Subject: Comments on Recently Received Documents Pertaining to
Seattle Tacoma International Airport Project
Third Runway – Low Flow Analysis

GeoSyntec Consultants (GeoSyntec) has been retained on behalf of the Airport Communities Coalition (ACC) to provide a technical review of investigation, analysis and design relating to geotechnical and hydrogeological elements of the proposed Third Runway Expansion Project at the Seattle Tacoma International Airport. GeoSyntec has previously commented on seismic and geotechnical aspects of the embankment fill and Mechanically Stabilized Earth Wall. In my October 2001 declaration in support of ACC's motion for stay, I raised numerous concerns relating to the Port's Low Flow Analysis. This letter presents an expansion on the issues raised in the declaration based largely on review of the November 27, 2001 report by Pacific Groundwater Group (PGG) titled "Port of Seattle - Sea-Tac Third Runway - Embankment Fill Modeling in Support of Low Streamflow Analysis."

Figure 1 - SeaTac Embankment Fill Grain Size Analysis

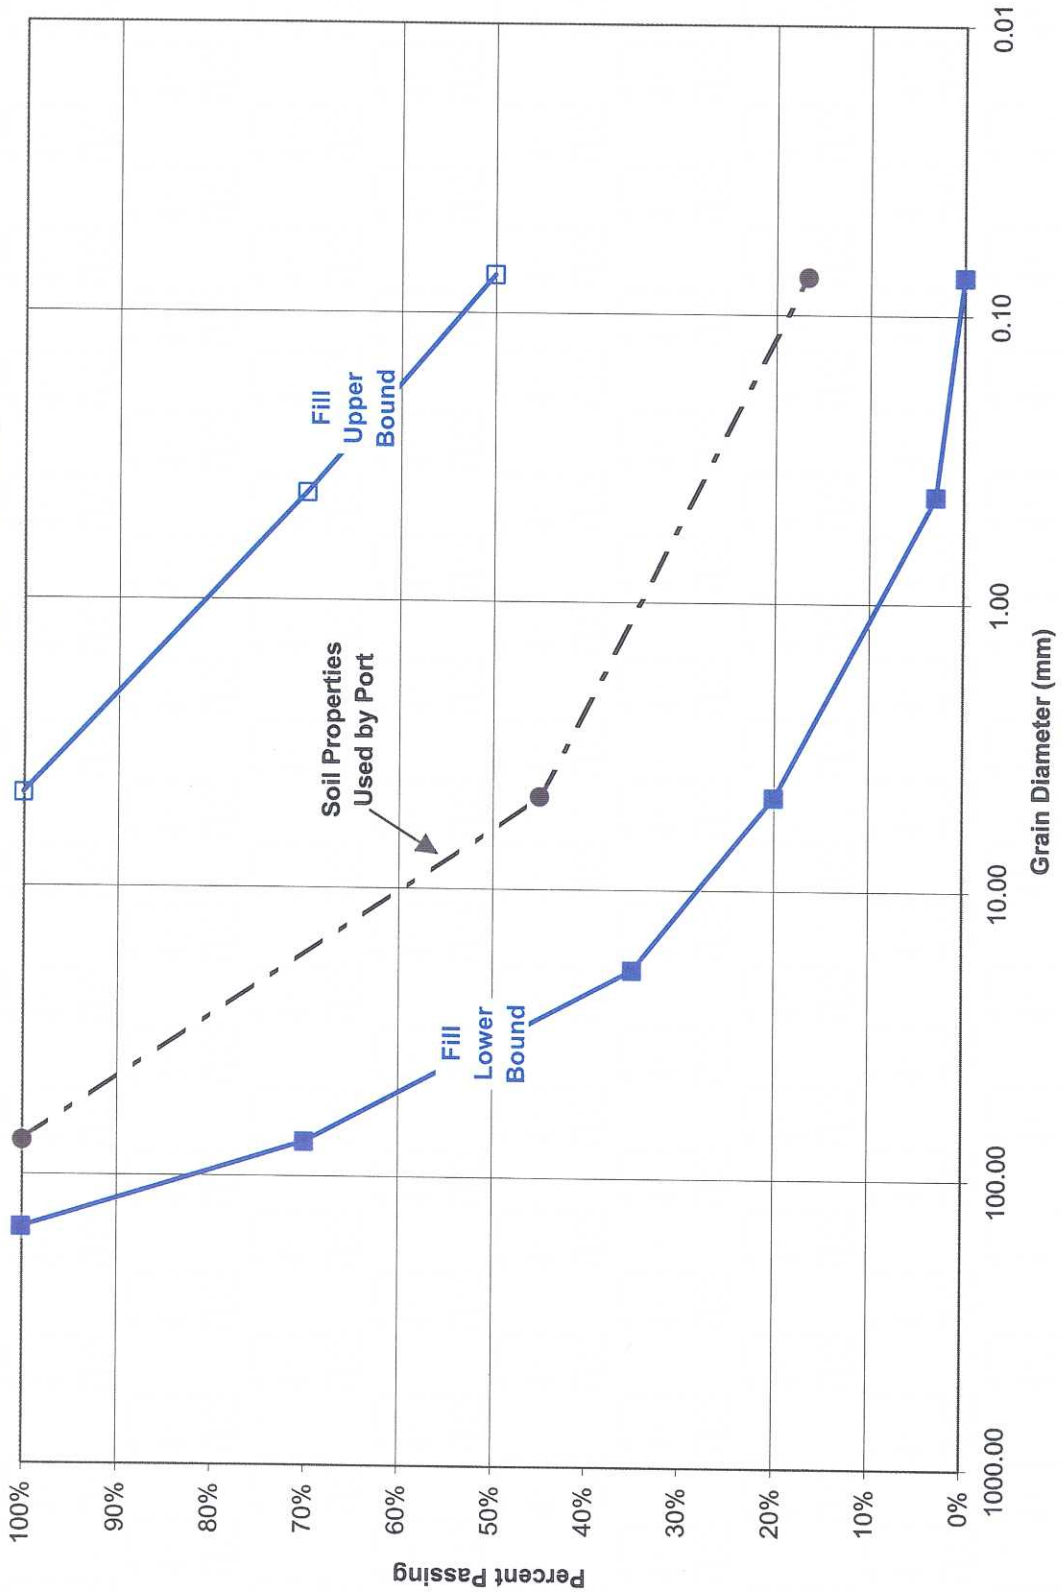
Comment 2: The analysis relies on a single set of soil parameters to represent the behavior of 20 million cubic yards of fill that will be obtained from numerous different borrow sources. This is a gross oversimplification and will lead to significant discrepancies between the predicted streamflows and those that would actually occur after construction.

The attached Figure 1 presents the range of soil grain sizes allowed by the project specifications and presents the single grain size representation used in the low flow analyses. Fill placement during construction of the embankment will occur in horizontal layers. As a result, there will likely be large areas of fill with fine-grained, low hydraulic conductivity material which will control the rate at which water flows vertically through the embankment. The overall hydraulic conductivity of the actual soil in the embankment could be several orders of magnitude less than that assumed for the current low flow analyses. This difference in hydraulic conductivity will have a substantial effect on the predictions made in the current analyses.

The current low flow analyses should not be accepted without a proper parametric evaluation of the influence of soil parameters on flow paths and travel times. A comparison of the soil parameters used for the low flow analyses and the range of soil types allowed for construction indicate that the flow rates through the embankment will be significantly more variable than the current analyses would indicate. That variability will likely increase the vault storage volumes required to protect low flow conditions in the creeks.

Figure 2a: Van Genuchten Parameter Variability

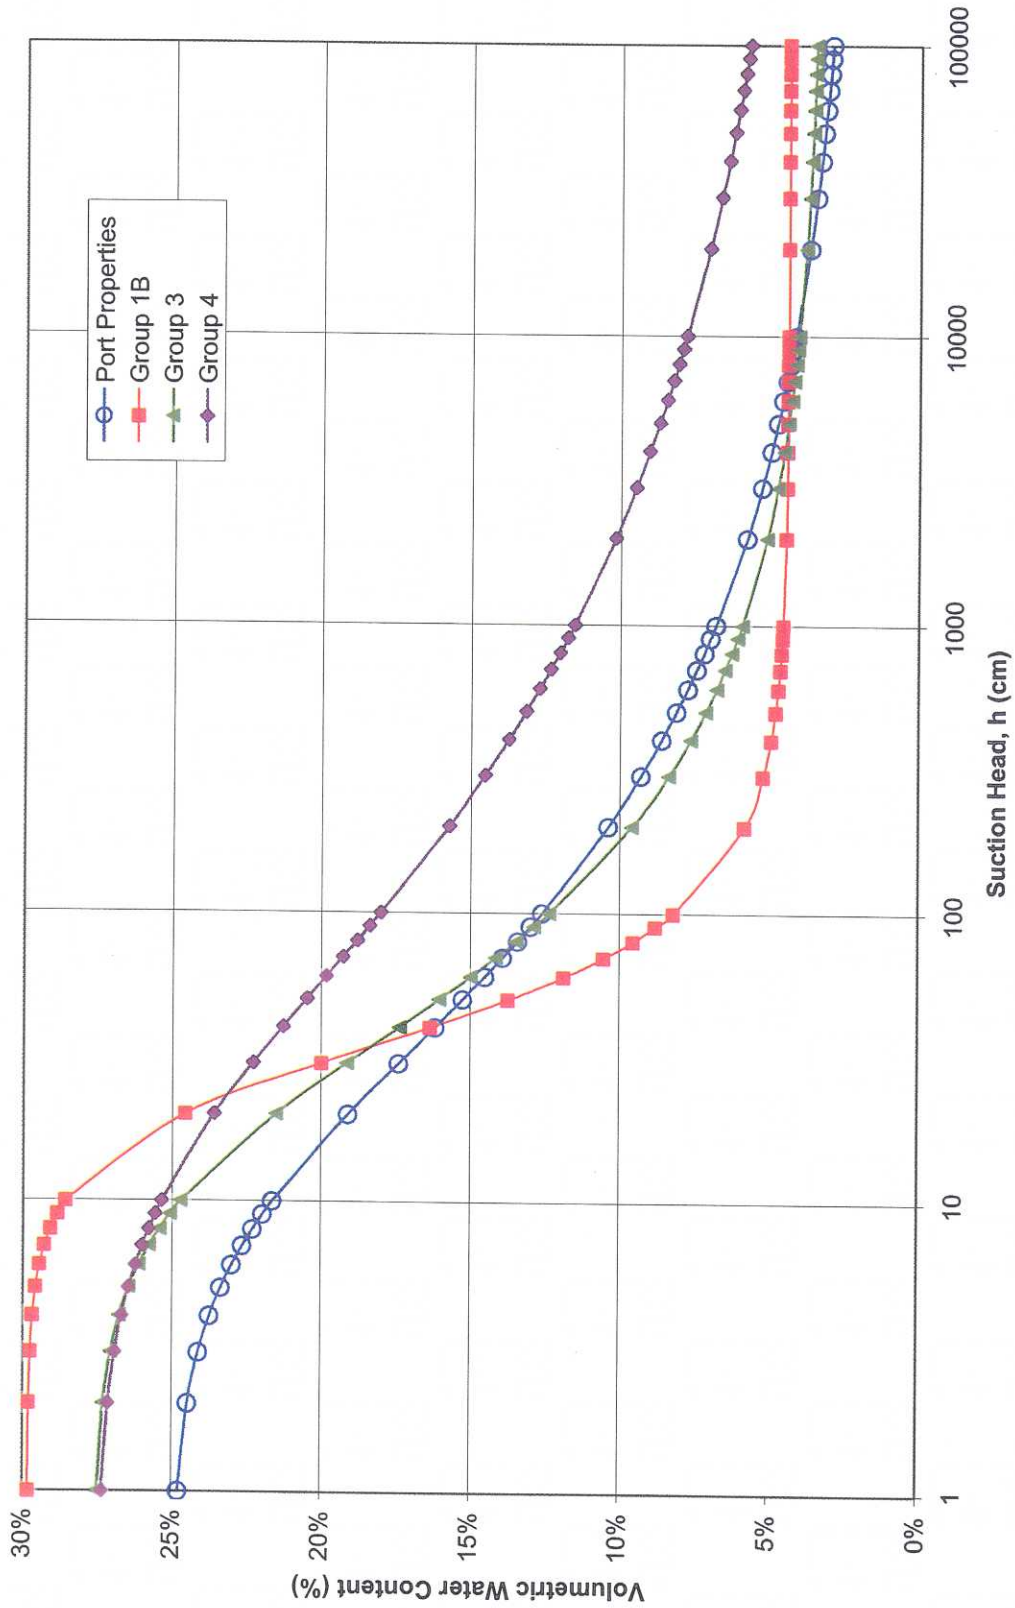
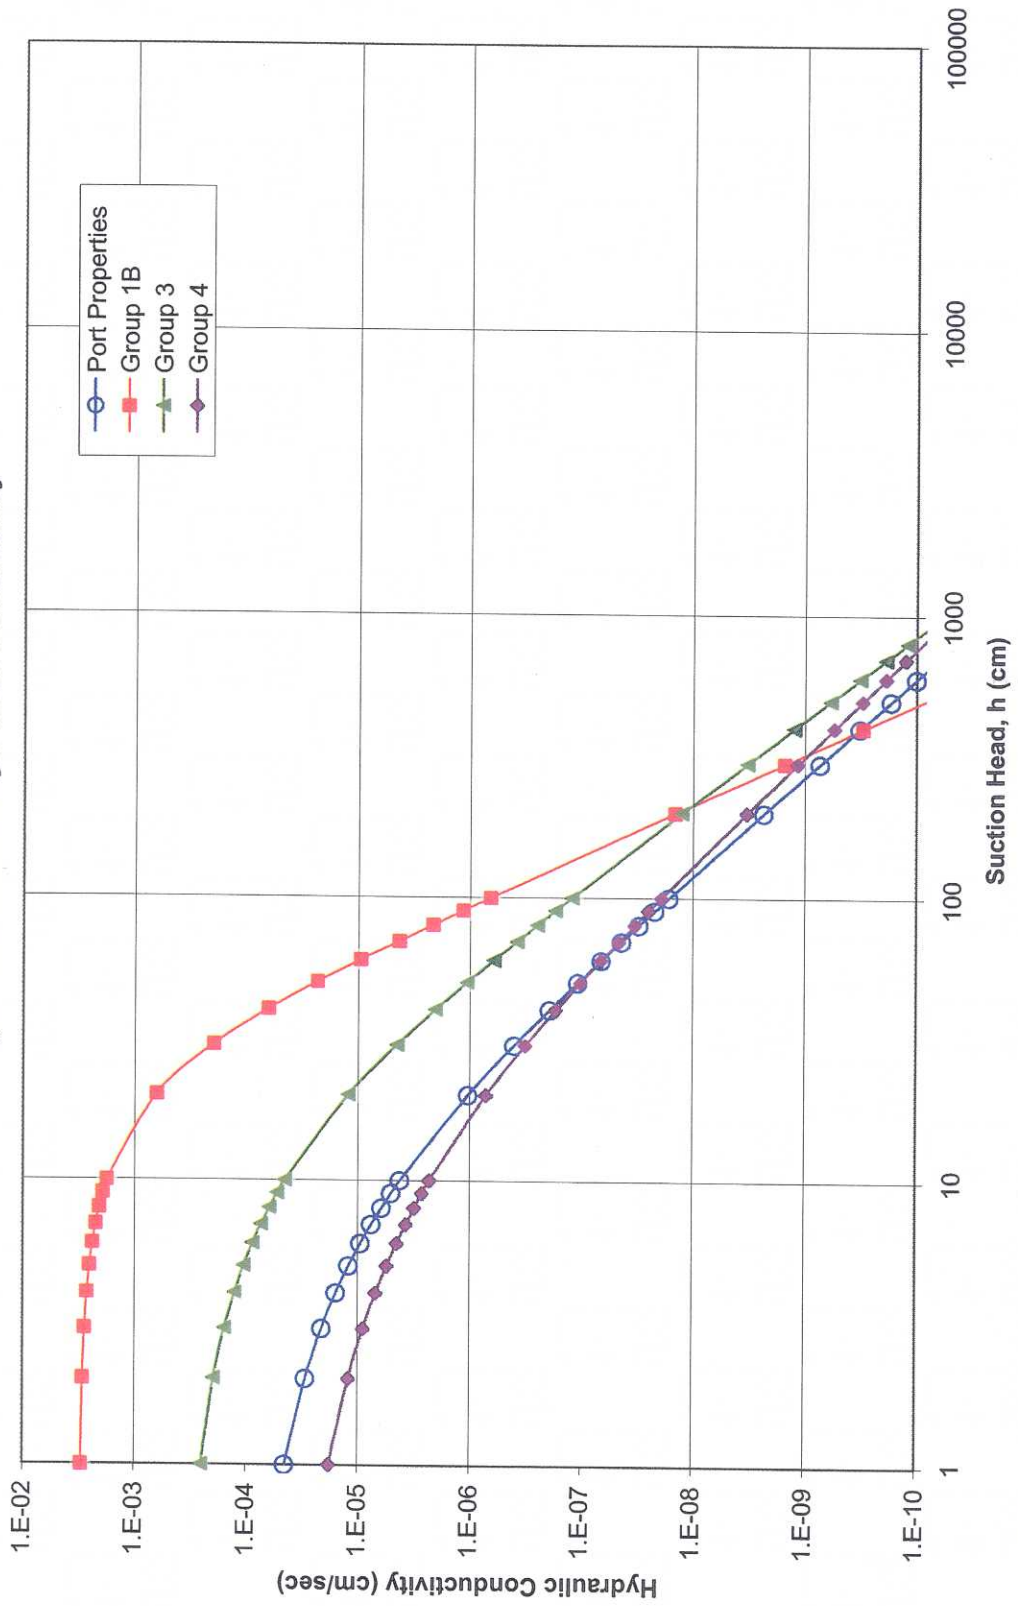
In Hart Crowser's "Embankment Infiltration and Seepage Studies" report², they presented unsaturated flow parameters and corresponding unsaturated behavior curves for three of the fill types proposed for the embankment (Group 1B, Group 3, and Group 4). Figures 2a and 2b present the representative curves developed by Hart Crowser for the three fill types, along with the single set of curves being used presently by PGG in their Hydrus modeling (labeled "Port Properties"). While Hart Crowser's modeling with the HELP program was overly simplistic and their method of accounting for gravel content was not well validated, their performance of parametric studies on the fill types was a step in the right direction compared to the single fill type currently being modeled in Hydrus. The Hart Crowser properties show that the hydraulic conductivity (which controls the rate at which water will pass through the fill) can range over several orders of magnitude for soils likely to be placed in the embankment. The figures clearly show that the single curve being used by the Port is not representative of the potential range of behavior.

Figure 3: 1-Dimensional Column Initial Lag Times for Infiltration to Reach Drainage Layer under Varying Soil Properties and Column Heights

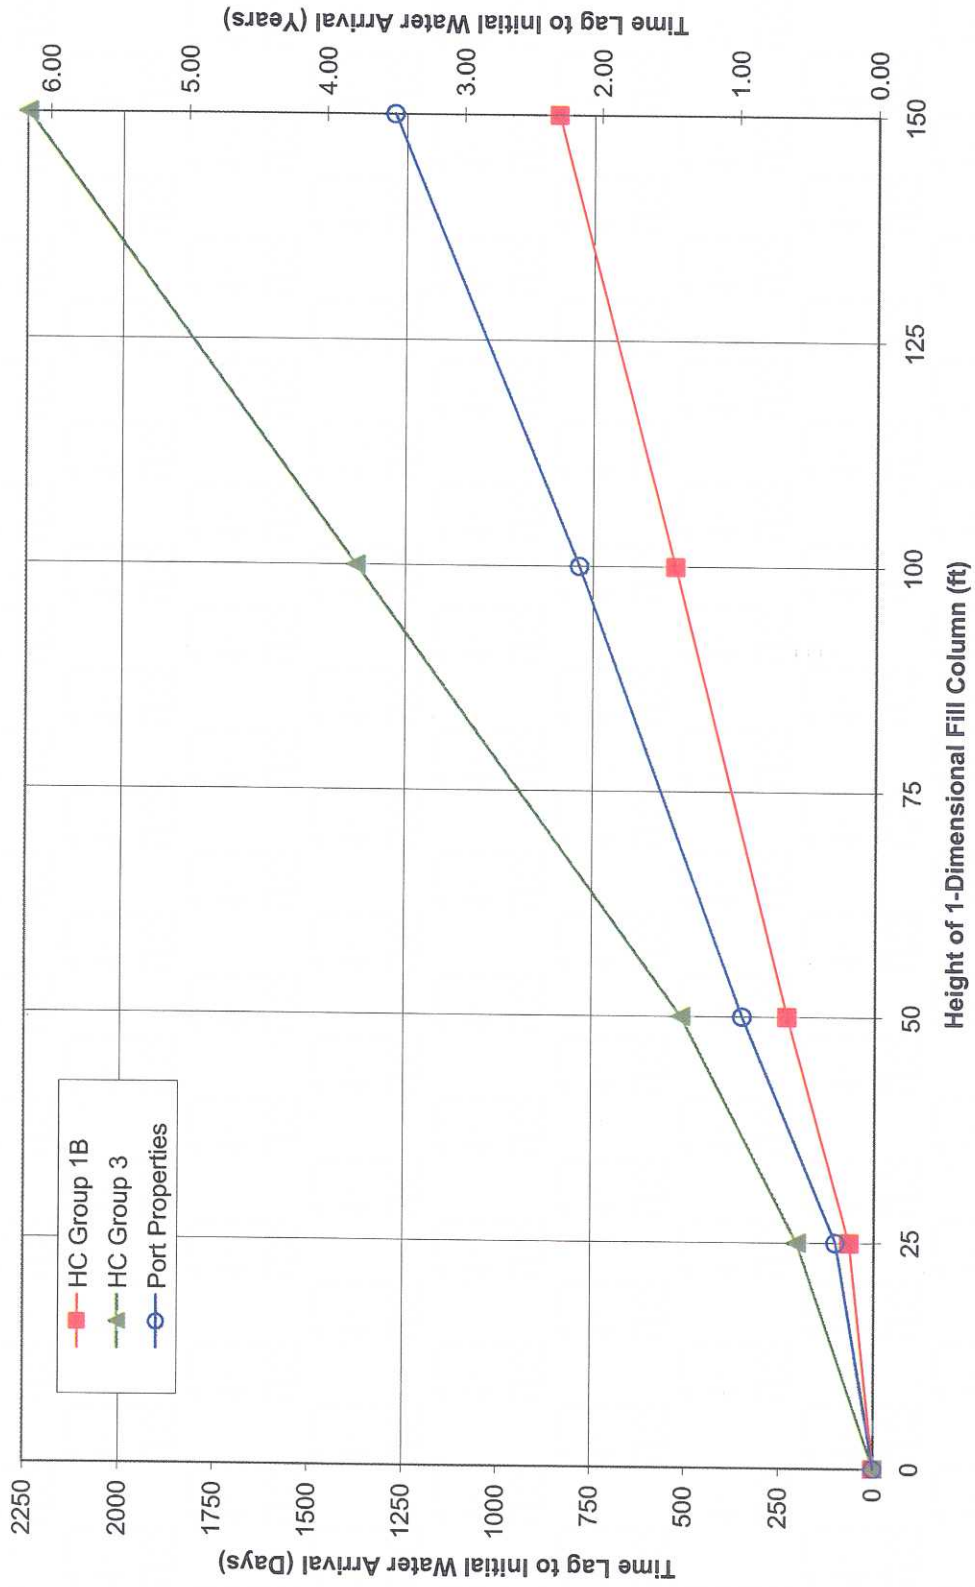
In order to demonstrate the influence of the variability of soil properties on the lag time between embankment construction and first arrival of water at the drain, several simple cases were analyzed. 1-Dimensional columns of varying fill thickness (25 ft, 50 ft, 100 ft, and 150 ft) were modeled using Hydrus for three different sets of fill properties (Hart Crowser Group 1B, Hart Crowser Group 3, and the Port Properties). The 1-Dimensional columns were modeled in a fashion similar to the Port's analyses, where all infiltration was assumed to travel vertically through the fill, without an allowance for horizontal flow. Figure 3 shows the results of these analyses. A curve is shown for each set of properties, immediately revealing the potential for variability in the results. Each point on the curves represents the time between the beginning of the analysis (Day 0) when the precipitation record begins, and the time when the first water reaches the drain at the base of the column. As the height of the 1-Dimensional column is increased (i.e. as the embankment fill thickness increases) the time lag increases relative to the properties for each fill type. For example, for a 50 ft fill thickness, the range of time lags shown is 250 to 500 days (approximately 0.7 to 1.4 years), and for a 150 ft fill thickness, the range is 850 to 2250 days (approximately 2.3 to 6.2 years). It will be shown later that ignoring the horizontal flow component in the fill (i.e. performing a 1-Dimensional analysis) results in an overestimation of the rate at which water flows through the fill, and thus the predicted lag times will actually be even longer than these values. In any case, the differences clearly demonstrate the potential variability in results which the port is ignoring in their analyses. Incorporation of this type of

parametric study in the Port's analysis will likely have a significant impact on the design of the Port's low flow mitigation scheme and is absolutely necessary for proper representation of the possible impacts of the embankment fill.

Figure 4a: Current Model System, all flow travels vertically through sand & silt matrix

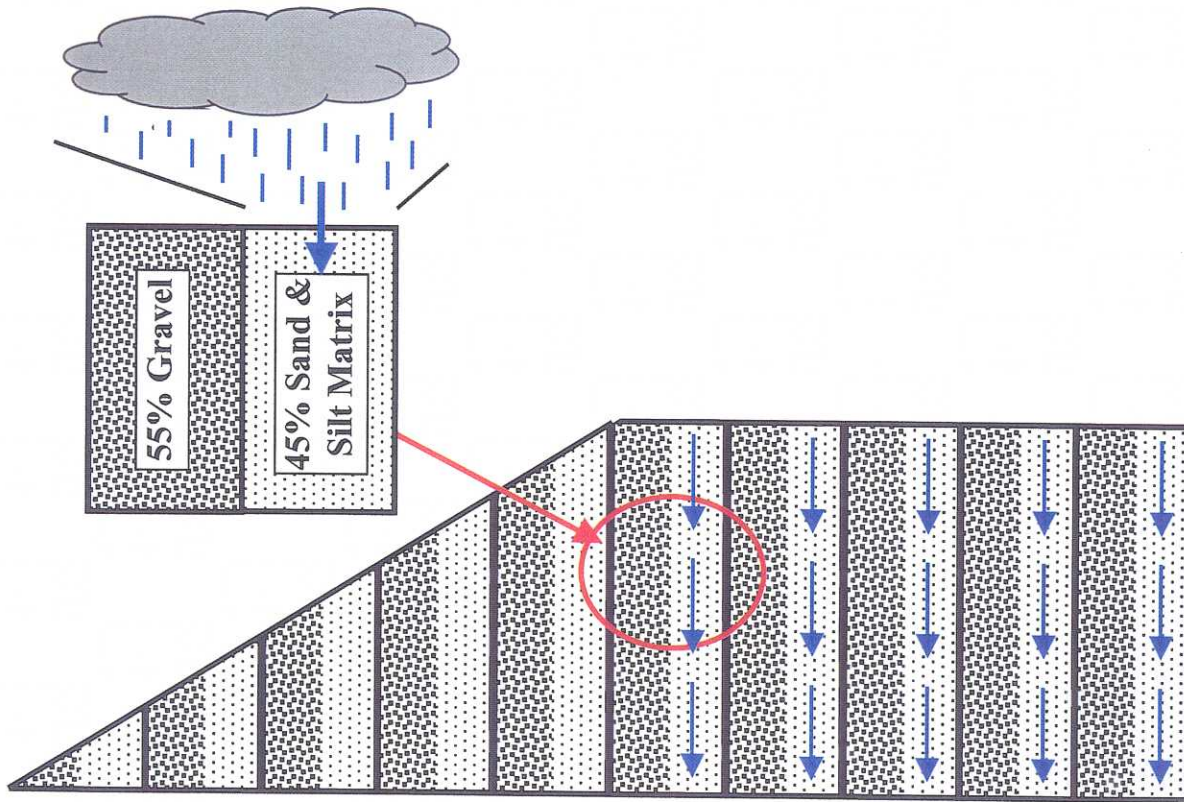
In addition to the Port's ignoring the gravel content of the embankment fill, their analysis consists of a series of 1-Dimensional columns of soil of varying thickness which force the infiltrating water to travel downward unimpeded without any lateral migration. Figure 4a shows a schematic of the system the port is actually modeling. Each column theoretically consists of 55% gravel and 45% sand and silt. However, water falling on any given column of soil is forced through the sand and silt matrix (achieved through artificial adjustment of precipitation and discharge quantities), bypassing the gravel completely. It should also be noted that water falling on the sloping face of the embankment is assumed not to infiltrate at all, and because the water can only travel vertically, this region never sees any water at all.

represented by the Port (e.g. Figure 4a), and the time for water to travel through the embankment will be much slower than predicted.

Figure 4b: More realistic scenario, flow paths change continuously throughout profile

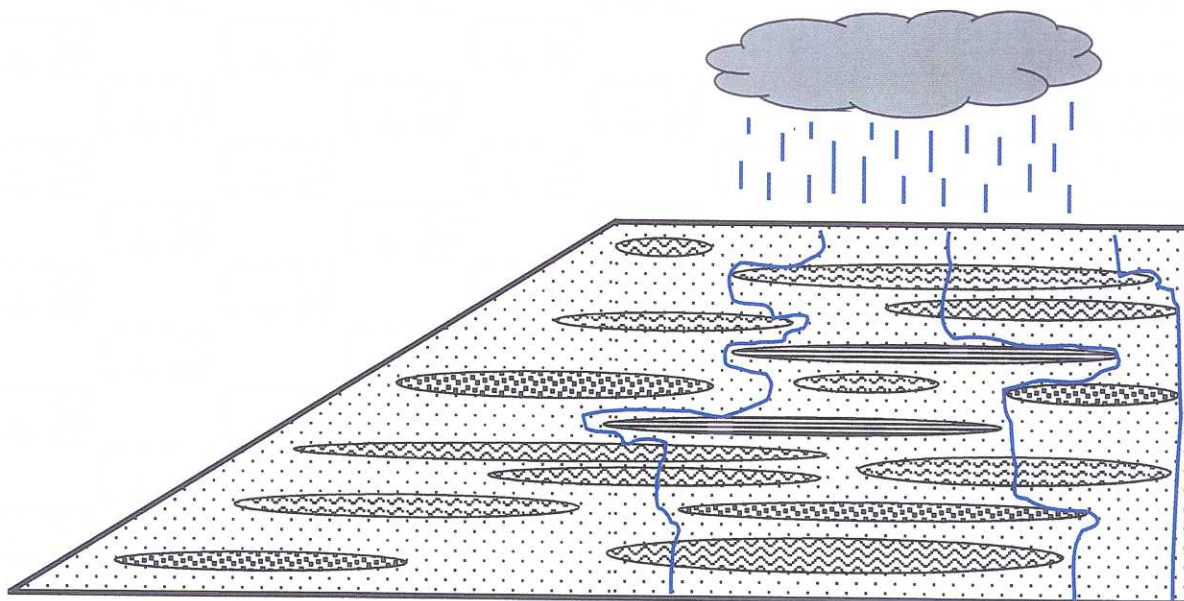
Figure 4b shows a schematic (which is still a simplification) of the type of layering that will exist in the embankment fill as a result of the construction process. 20,000,000 cubic yards of fill will be imported from numerous borrow sources and placed in horizontal layers at the then current elevation. The soil layers with the lowest hydraulic conductivity will control the vertical rate of flow of water traveling through the embankment. It will be impossible for the Port to control the fill sufficiently that an assumption of uniform flow behavior can be assumed realistically. The Port has failed to consider the very real variability of the soils that will be placed in the embankment. As a result of the fill layering, the flow path will be significantly more complex than
